Agenda
Village of Arlington Heights
Design Commission
Community Room, 3rd Floor

- A. DC#18-106 - Dunkin/Baskin Robbins - 105 W. Dundee Rd. / Commercial
- B. DC#18-108 - 7-Eleven Gas Station - 1650 W. Algonquin Rd. / Commercial

It is recommended that the Design Commission approve the proposed architectural design for Dunkin' / Baskin Robbins located at 105 W. Dundee Road. This recommendation is subject to compliance with the plans received 11/27/18, Design Commission recommendations, compliance with all applicable Federal, State, and Village codes regulations and policies, the issuance of all required permits, and the following:

It is recommended that the Design Commission approve the proposed design for 7-Eleven located at 1650 W. Algonquin Road. This recommendation is subject to compliance with the revised plans received 12/21/18, Design Commission recommendations, compliance with all applicable Federal, State, and Village codes regulations and policies, the issuance of all required permits, and the following:

1 CANOPY - NORTH ELEVATION
3/16" = 1'-0"

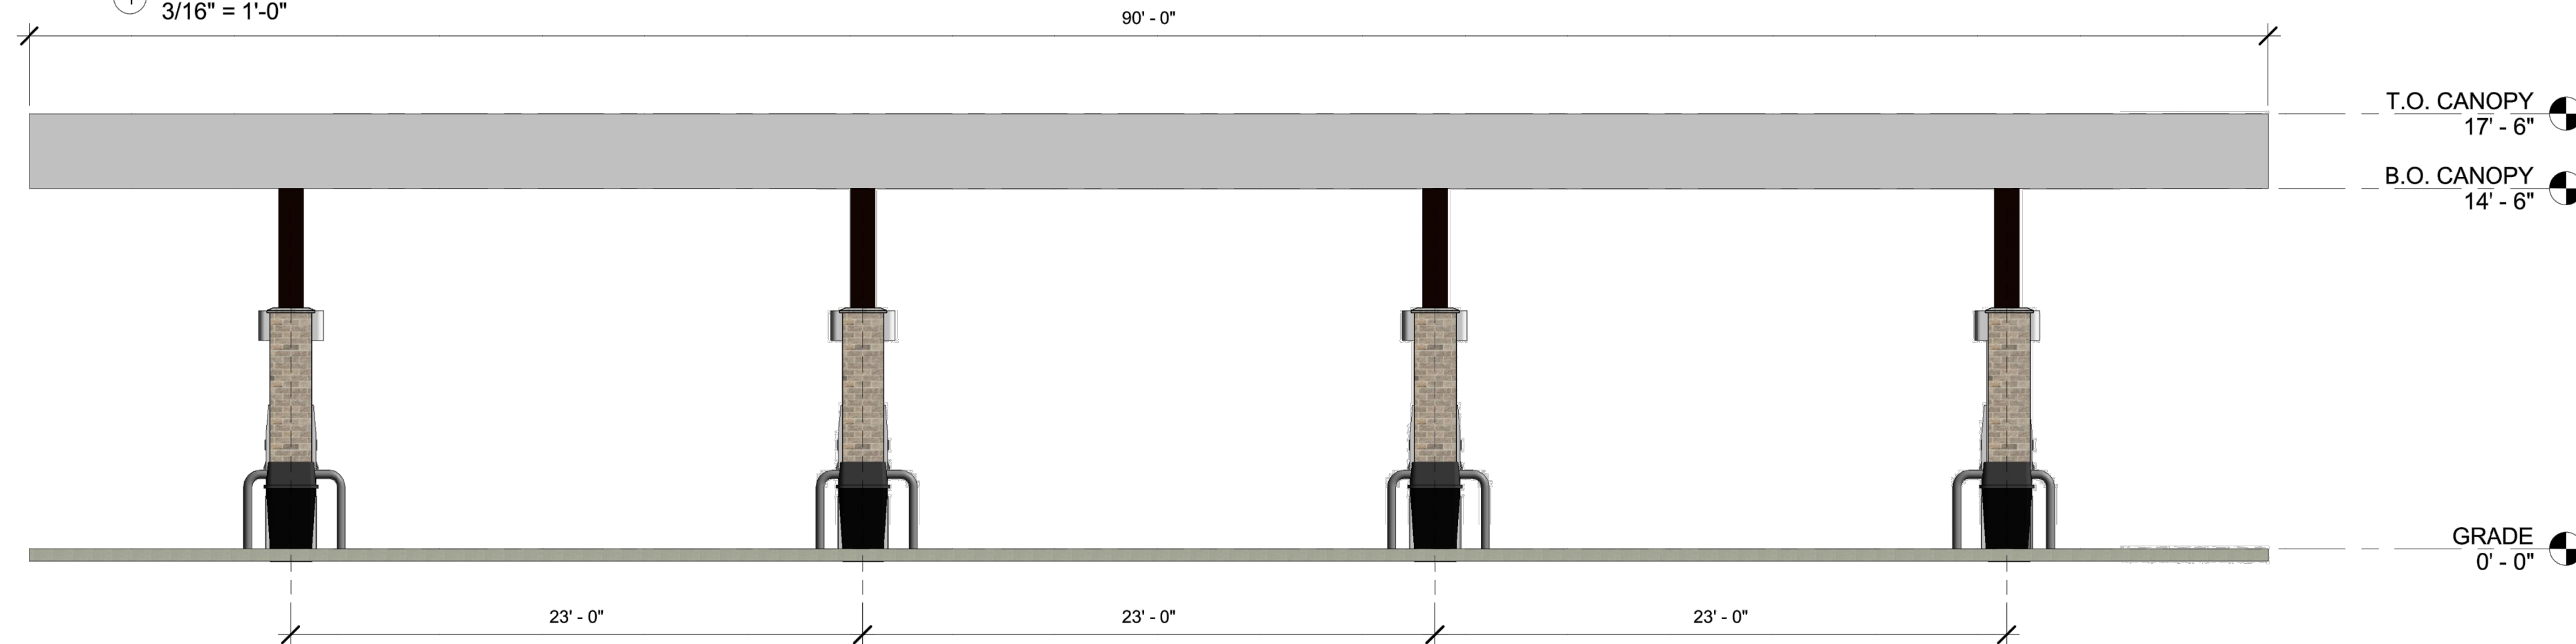
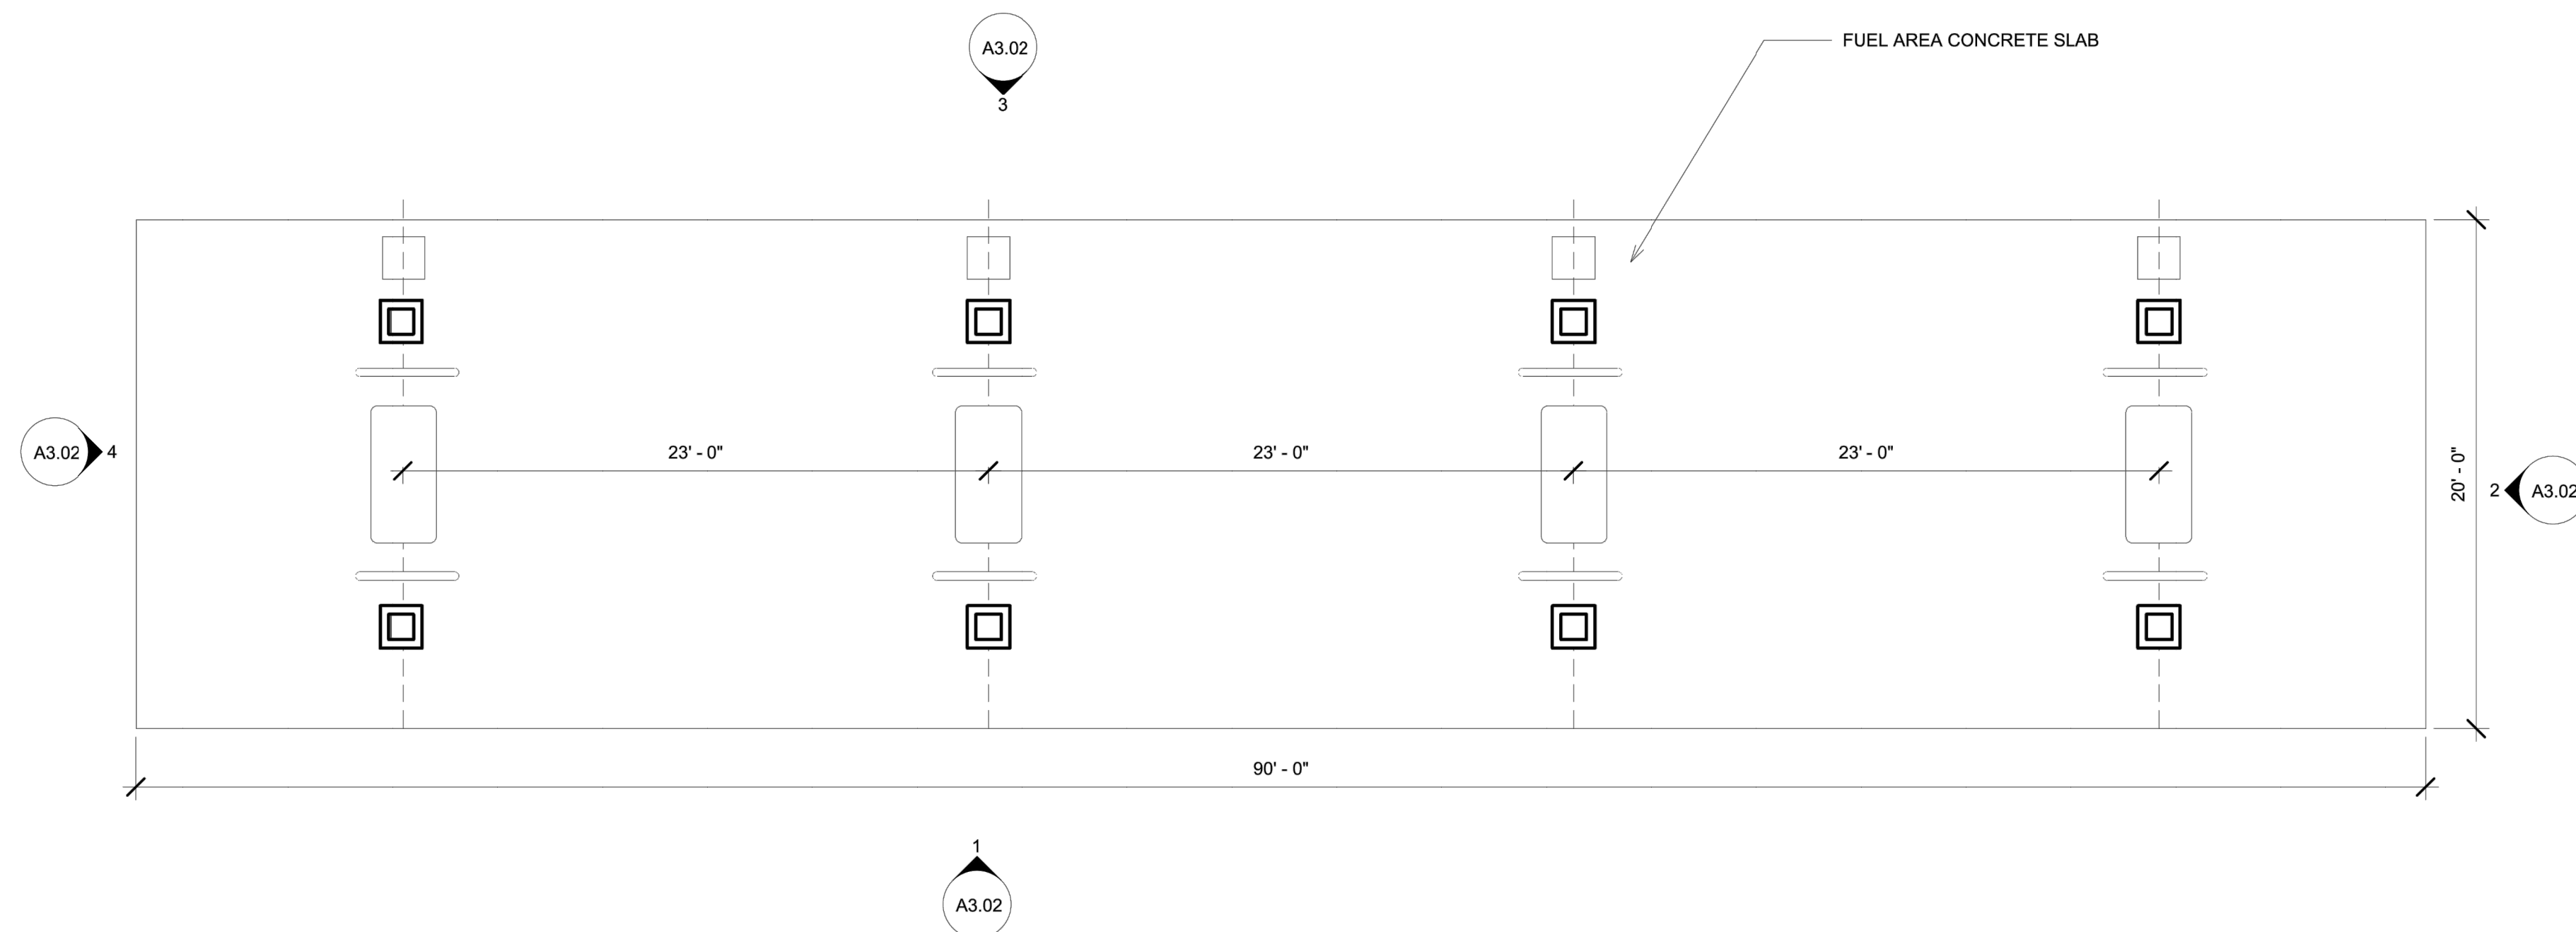
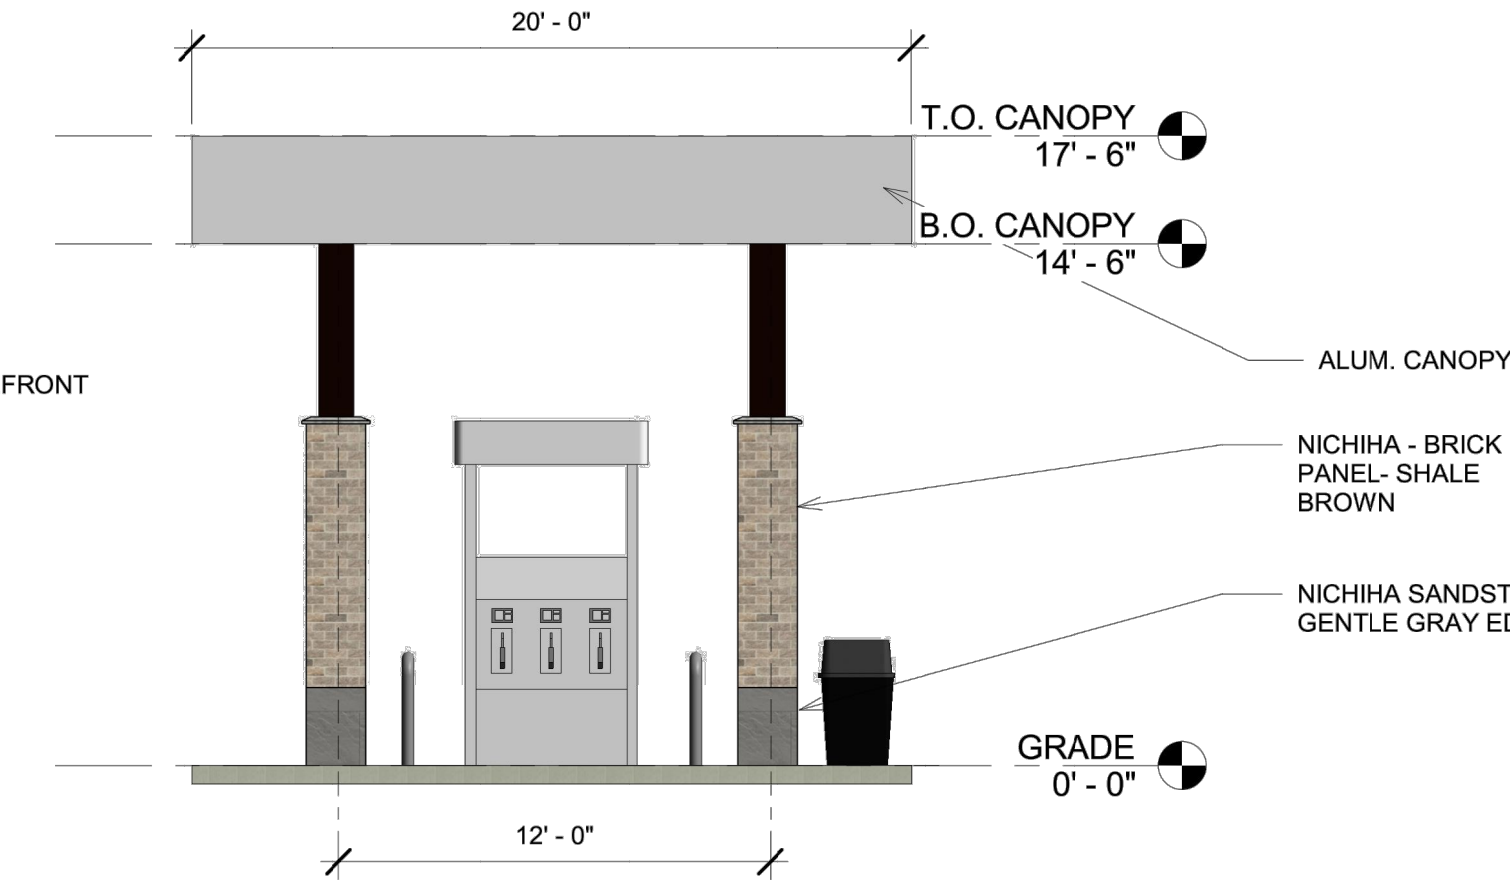
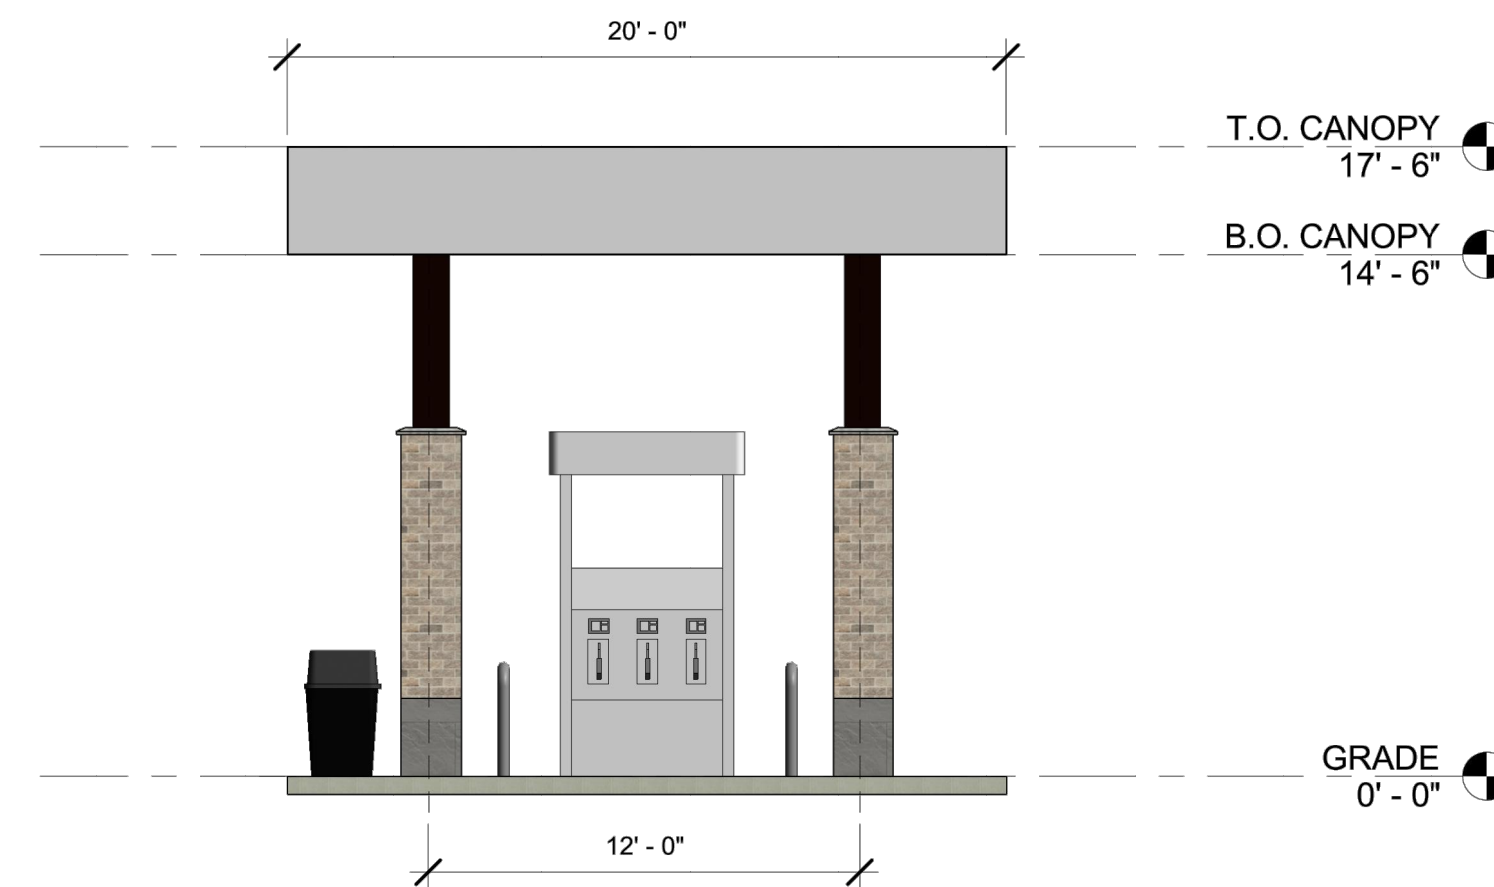
2. Consider omitting the stone panel detail on the fuel pump canopy columns and trash enclosure, providing an all brick appearance.
3. Signage shall comply with Chapter 30, Sign Code.

2. Consider omitting the stone panel detail on the fuel pump canopy columns and trash enclosure, providing an all brick appearance.
3. Signage shall comply with Chapter 30, Sign Code.
